AMENDMENT OF SOLICITATION	I/MODIFICATION OF	CONTRACT	1. CO	NTRACT ID CO	DE	PAGE OF PAGES 1 5
2. AMENDMENT/MODIFICATION NO. 0001	3. EFFECTIVE DATE 21 JUL 2000	4. REQUISITION/PURCHASE W81EU613422686	E REC	Q. NO.	5. PROJECT N NF - Bord	NO. (If applicable) Patrol

6. ISSUED BY CODE		7. ADMINISTERED BY (If oth	other than Item 6) CODE			
Department of the Army US Army Engineer District, Buffalo 1776 Niagara Street Buffalo, New York 14207-3199

Page 5 of 5
Amendment No. 0001 to
Invitation for Bids DACW49-00B-0013

PROJECT CONSTRUCTION SIGN

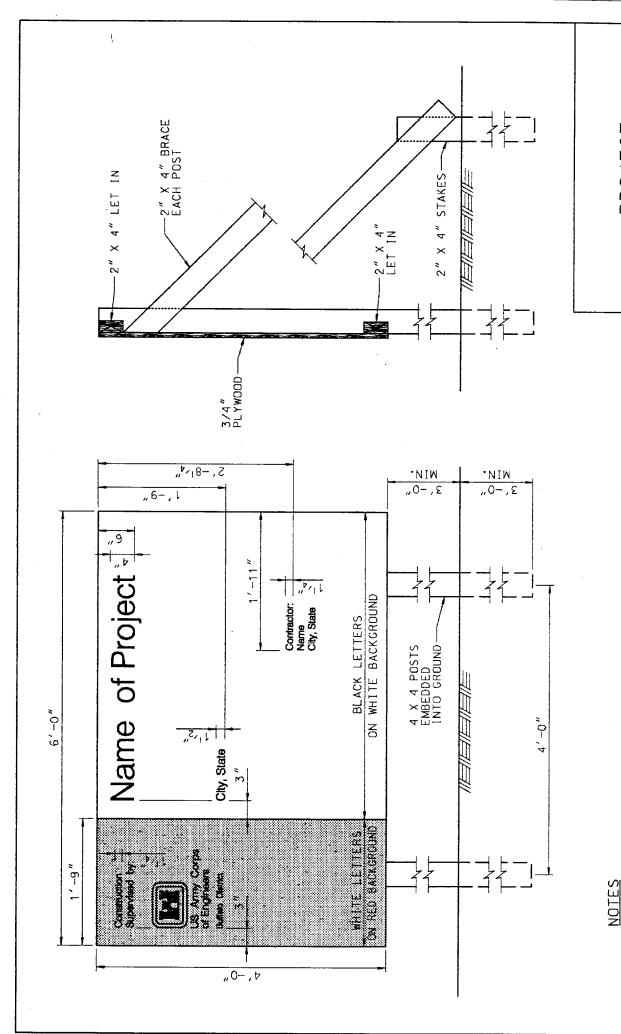
Attachments: "Project Construction Sign" is herewith attached.
